Amendments to the Drawings:

Remarks

This Amendment is in response to the Office Action mailed February 15, 2007. Claims 26 and 27 are newly added. Claims 6, 7, 9, and 24 have been amended. No new matter has been added to the Application. Claims 1-5, 8, 10-13, 15-23, and 25 have been cancelled. Claims 6, 7, 9, 14, 24, 26, and 27 will be pending in this Application upon entry of this Amendment.

FIG. 2 Prior Art

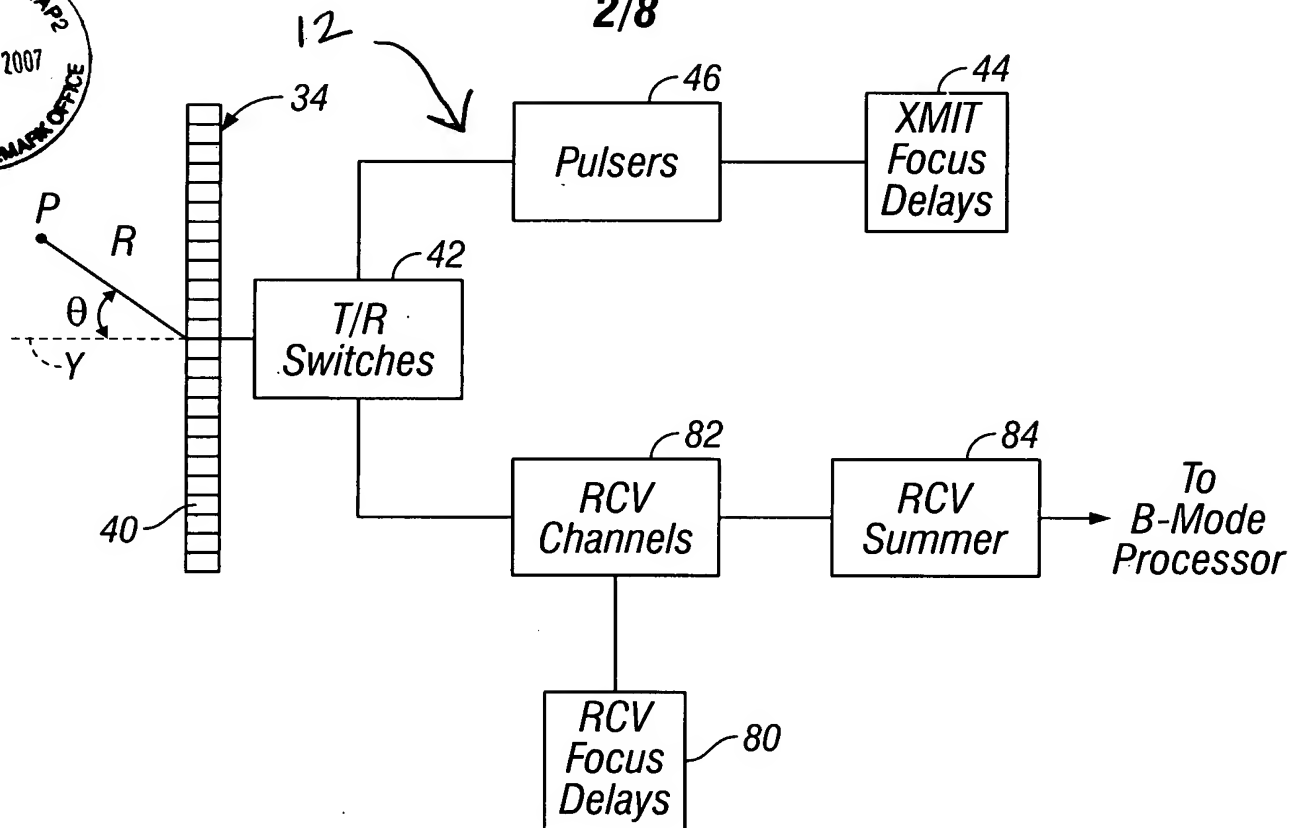
The notation "PRIOR ART" has been added to Figures 2-5 in the new drawing sheets. Also, Figure 2 has been changed to add reference numeral "12" thereto.

The objection to Figures 1-5 for not being designated as "prior art" is respectfully traversed.

Replacement Figures 2-5 have been designated as "prior art," as required by the Office.

Figure 2 has been amended to include the reference numeral for beamformer 12. Accordingly, this objection should be withdrawn.
